# DOCUMENT CHANGE REQUEST

DCR number 513 Changes required for: General

Title: Transistors Switching PNP, based on types 2N3636 and 2N3637

Number: 5208/003

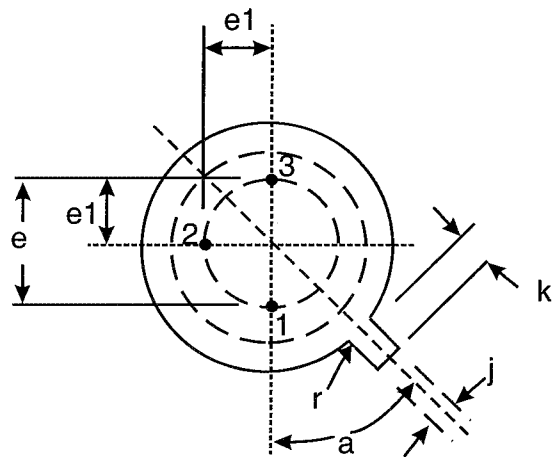
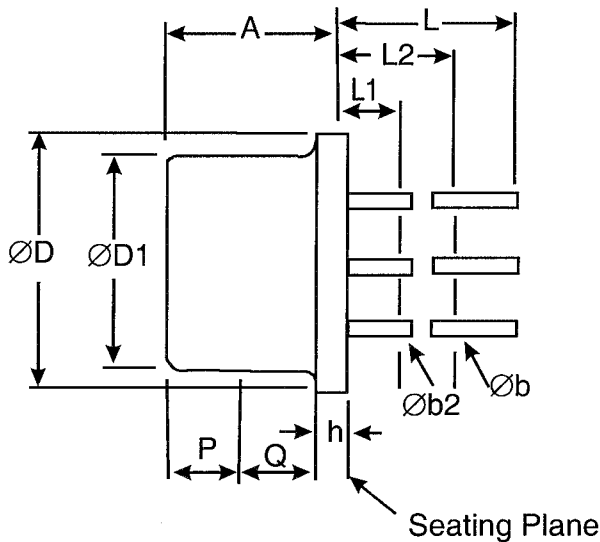
Update the Maximum Ratings table (see the attachment for details) so that this detail spec is clear, complete and the content and format is in-line with other detail specifications for similar Part Types.

Page 6: Original Note 2 to Maximum Ratings – add “, and any handling,” between “testing” and “performed”.

1. For  $T_{amb} > +25^{\circ}C$  derate linearly to 0W at  $+200^{\circ}C$
1. For Variants with tin-lead plating or hot solder dip lead finish all testing performed at  $T_{amb} > +125^{\circ}C$  shall be carried out in a 100% inert atmosphere.
2. Duration 10 seconds maximum at a distance of not less than 1.5mm from the device body and the same lead shall not be resoldered until 3 minutes have elapsed.
